PLANS AND DOCUMENTS referred to in the PDA DEVELOPMENT APPROVAL

Approval no: DEV2025/FLA/4175
Date: 06 February 2026

PROJECT
HERCULES STREET

SITE ADDRESS
19 HERCULES ST HAMILTON, BRISBANE QLD 4000

DRAWING TITLE
LEVEL 23

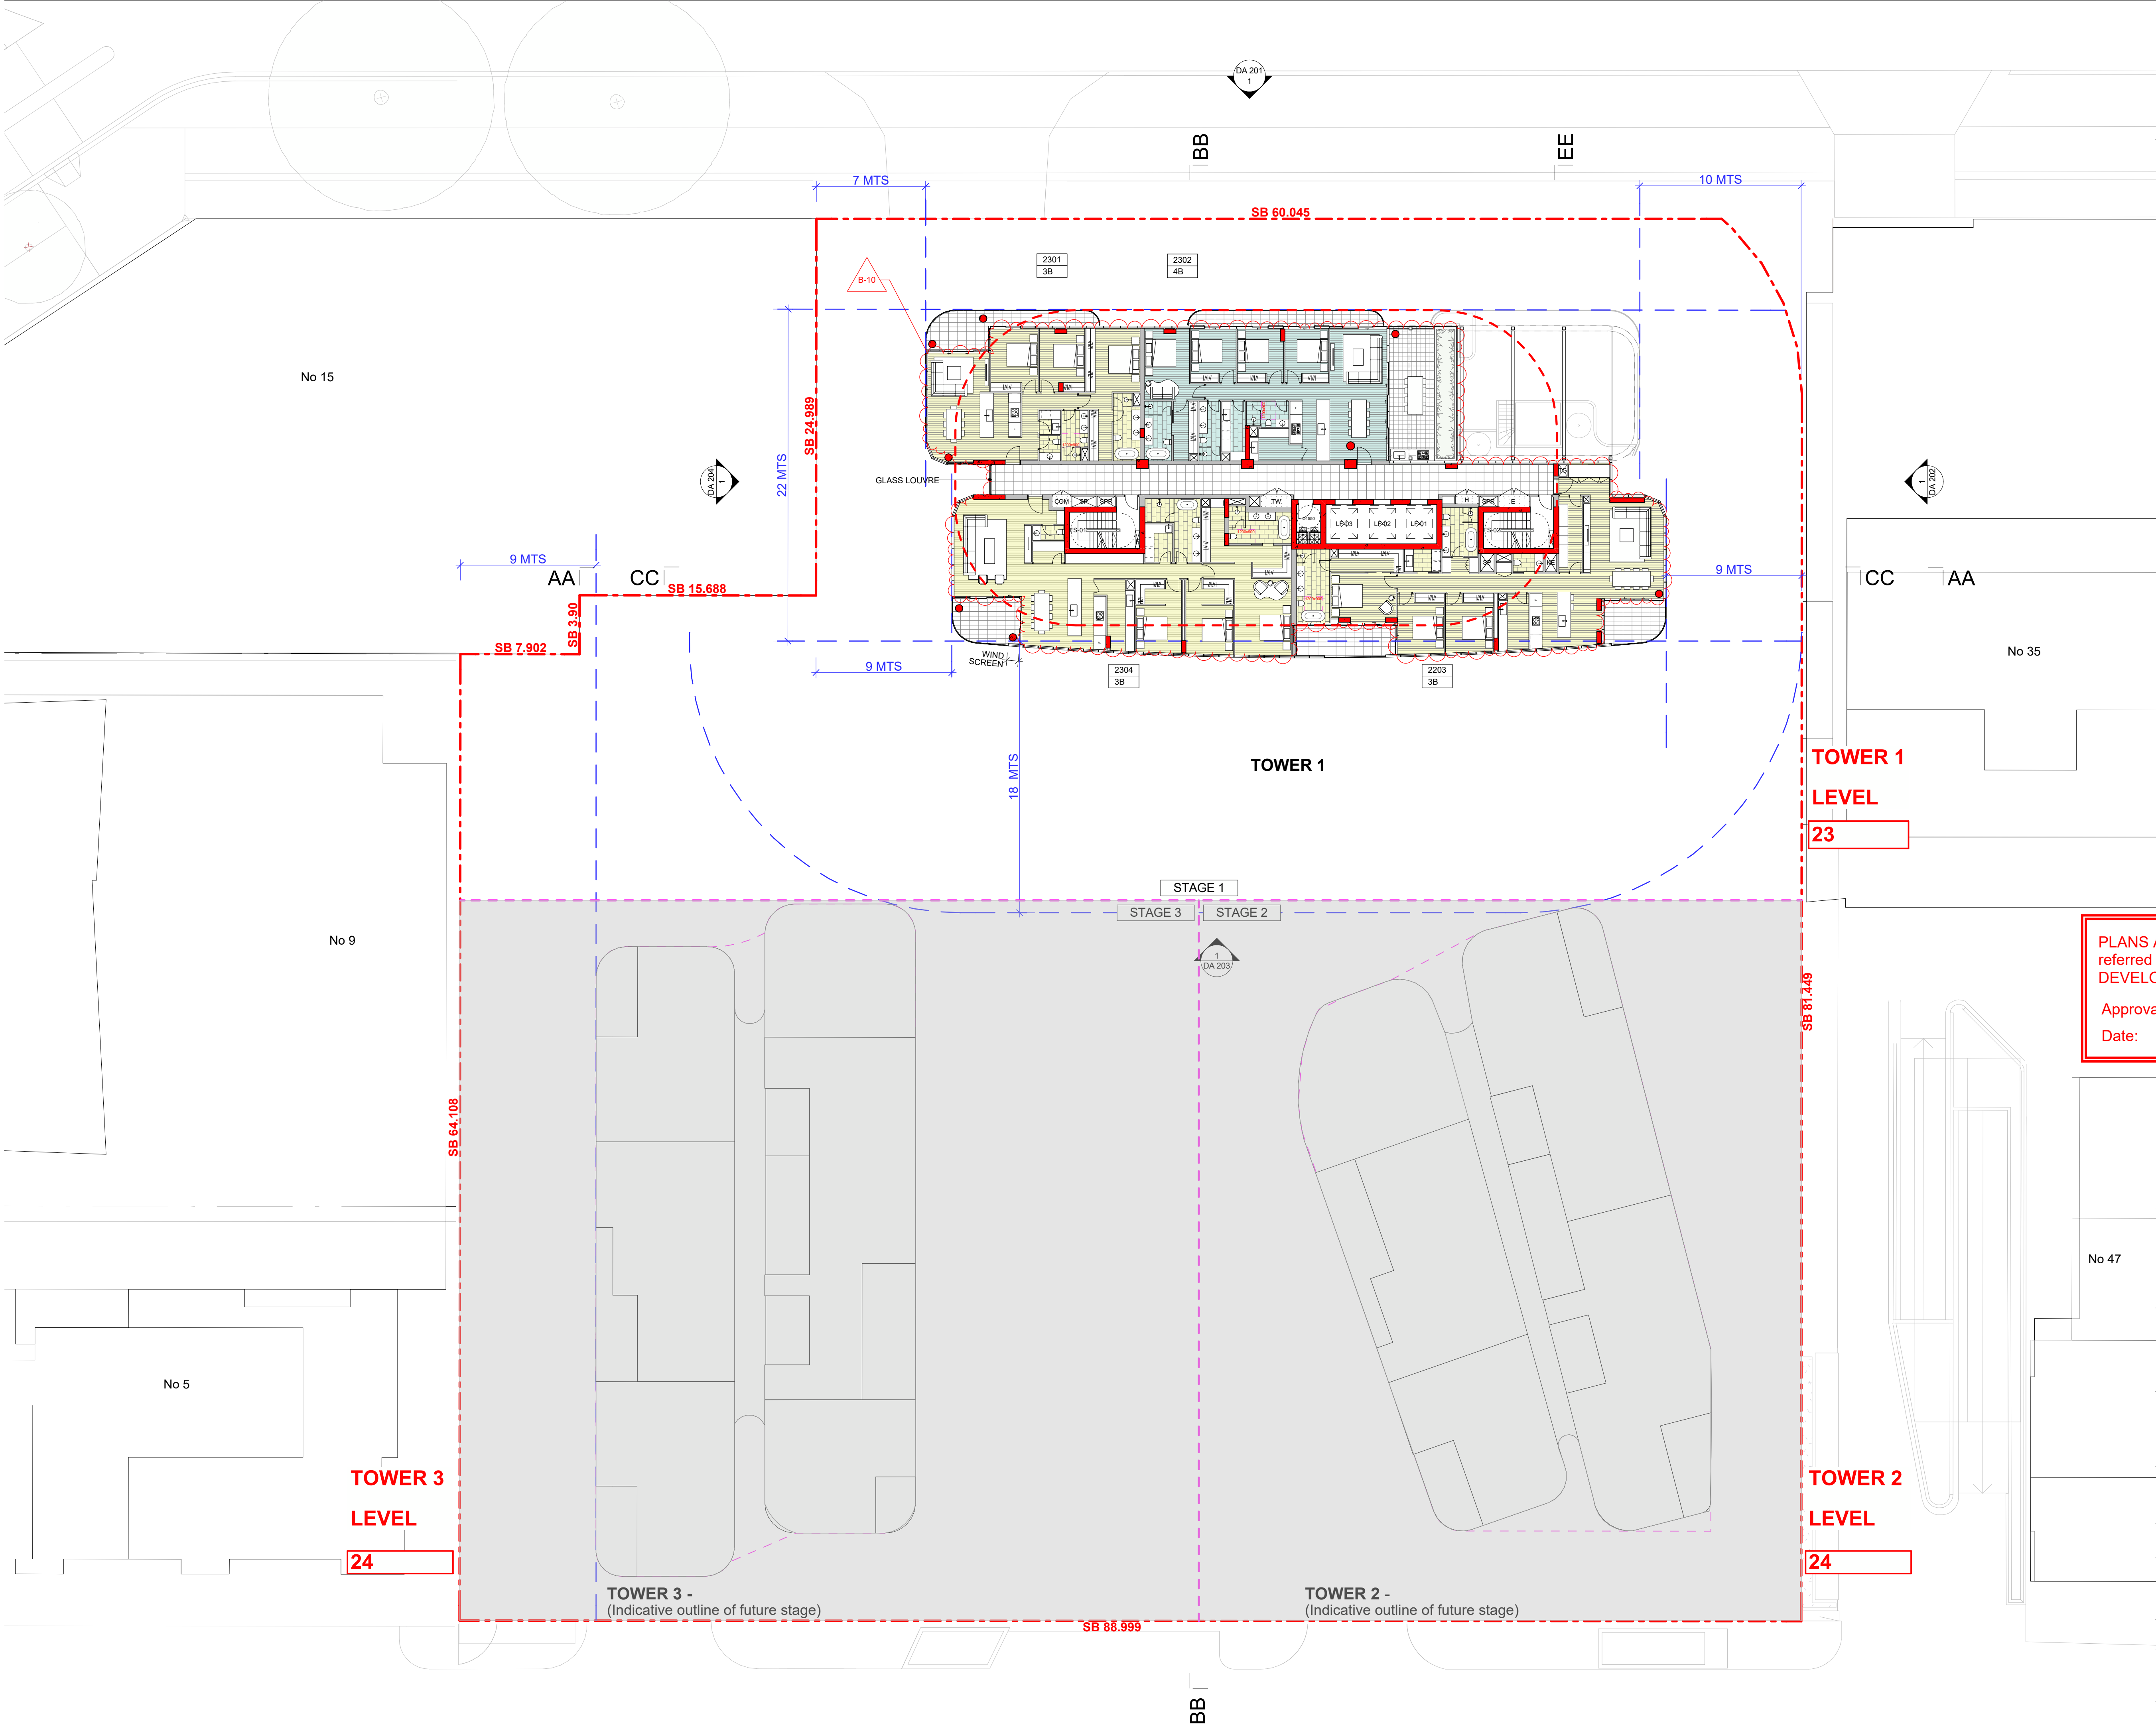
CHANGE	DESCRIPTION
B-10	INTERNAL LAYOUT OPTIMIZED

DRAWING TITLE
LEVEL 24

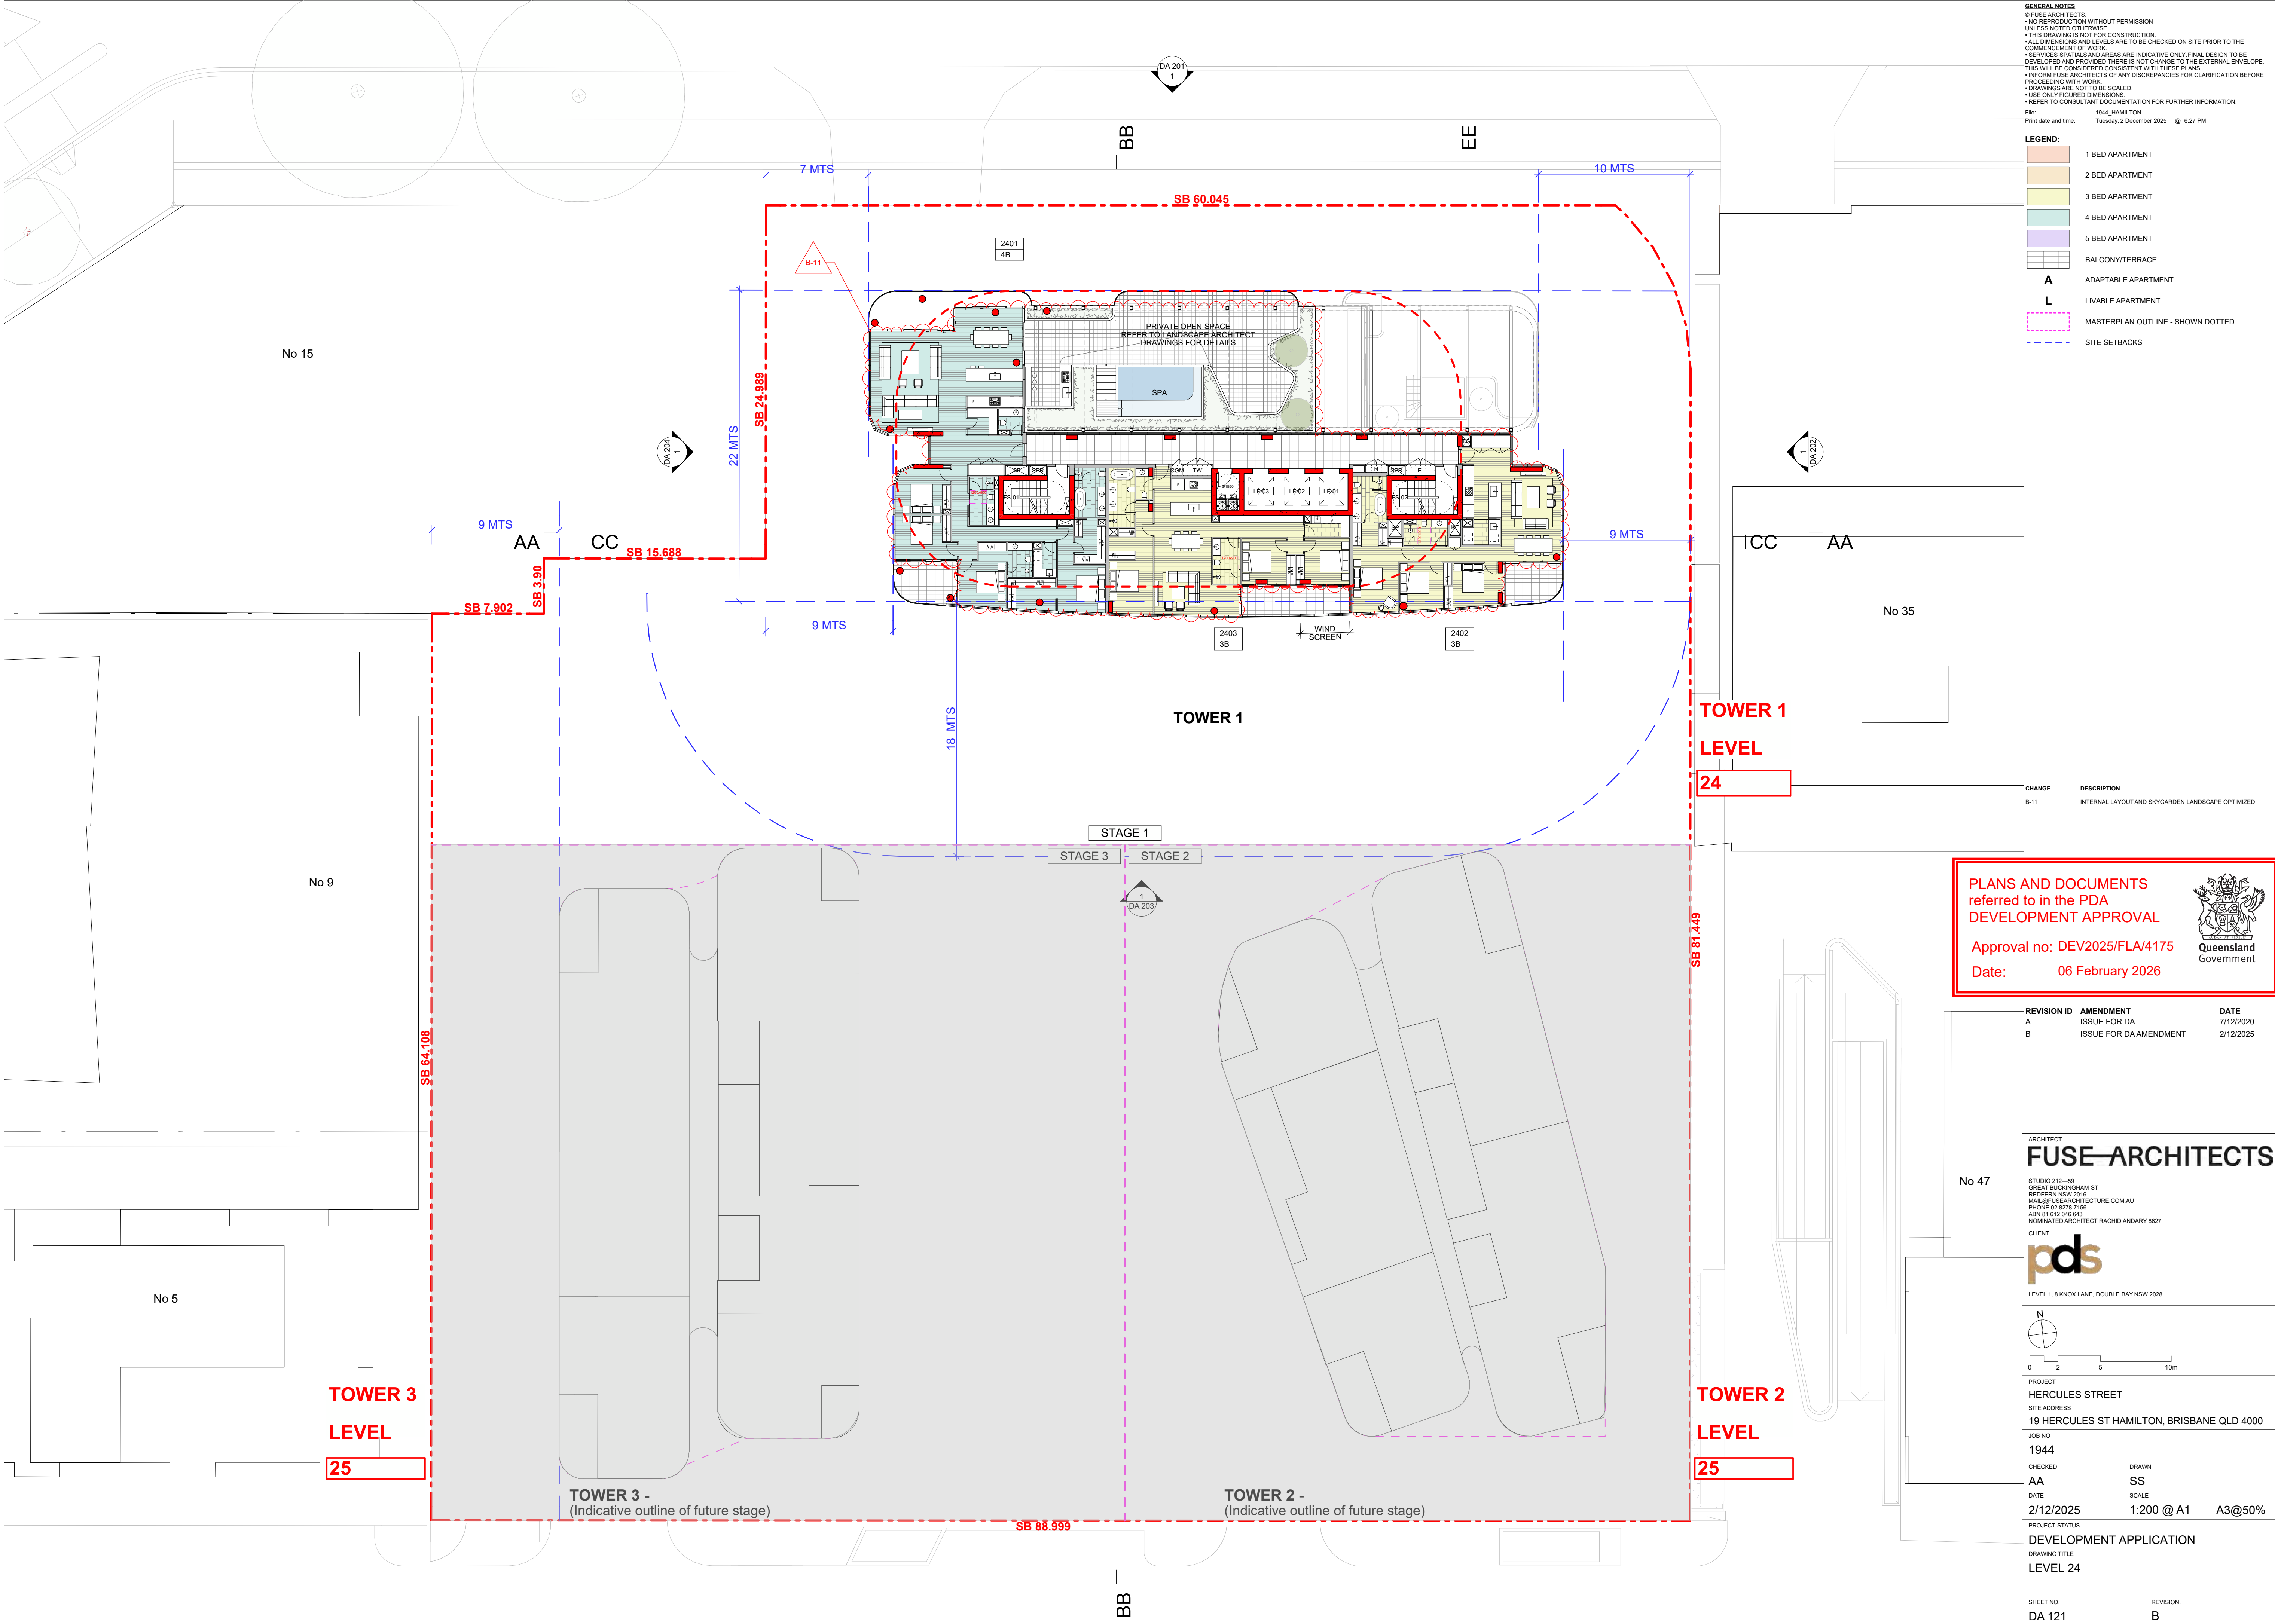
CHANGE	DESCRIPTION
B-11	INTERNAL LAYOUT AND SKYGARDEN LANDSCAPE OPTIMIZED

ROOF

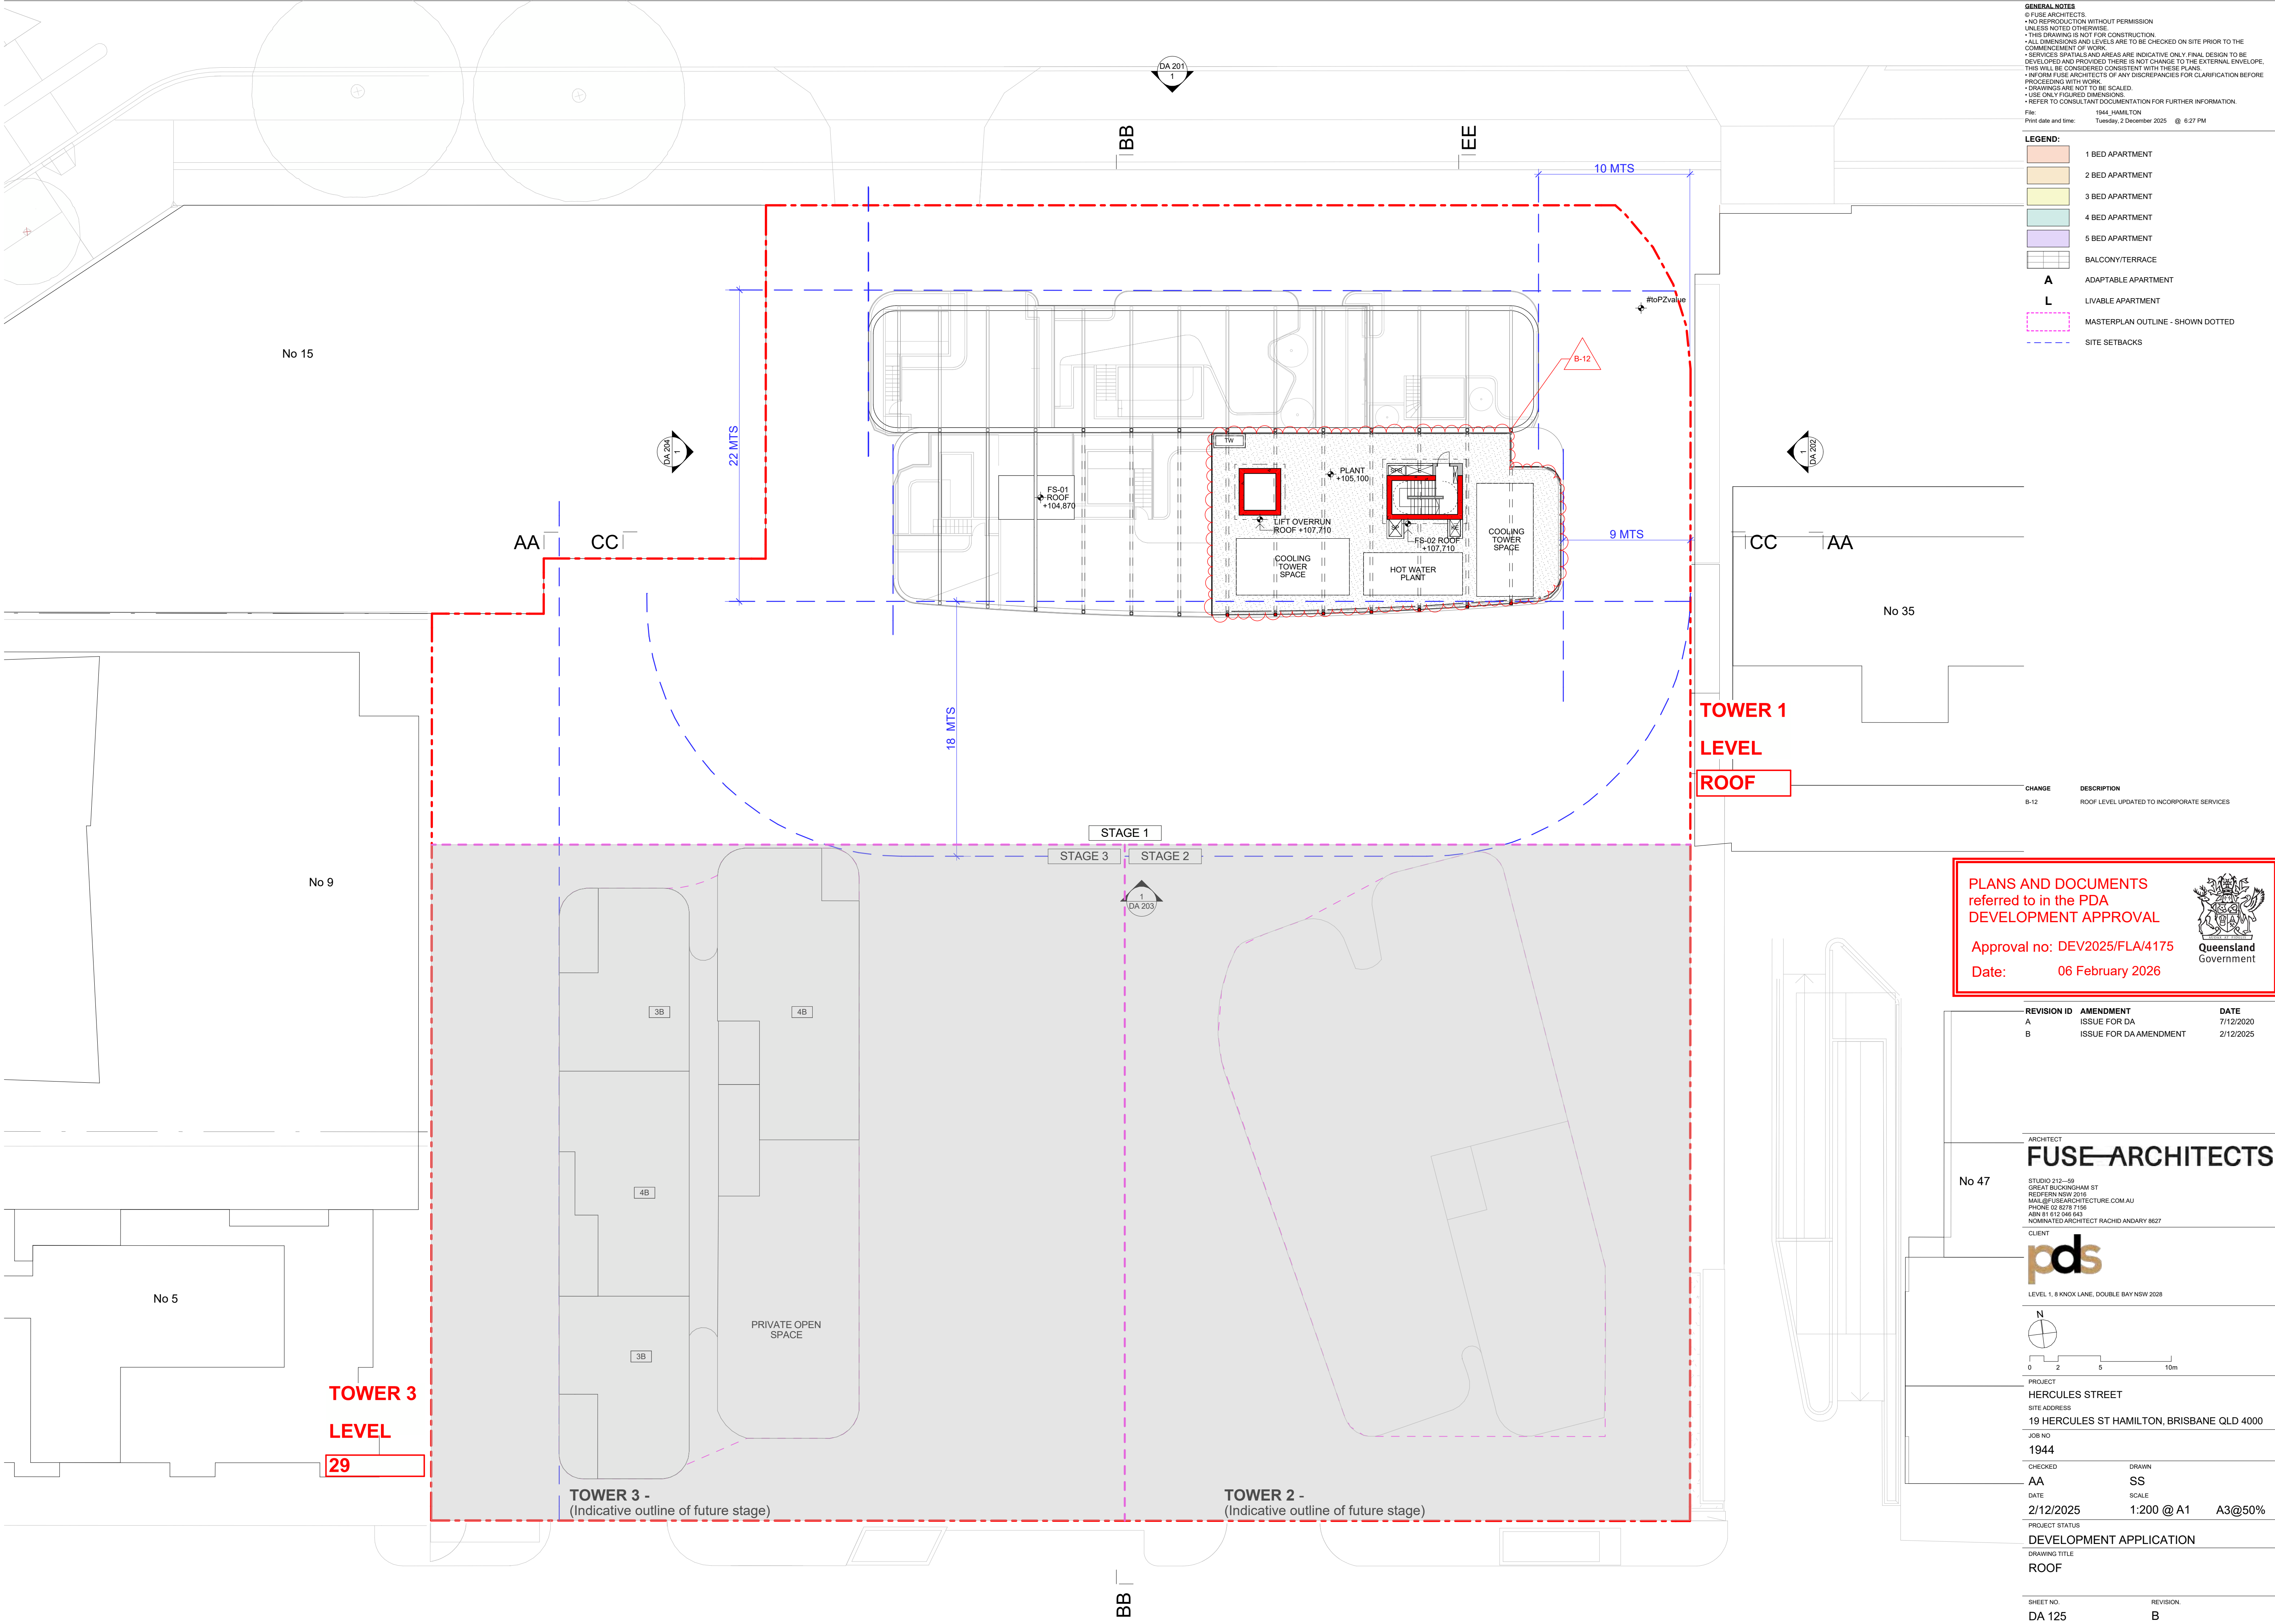
CHANGE	DESCRIPTION
B-12	ROOF LEVEL UPDATED TO INCORPORATE SERVICES
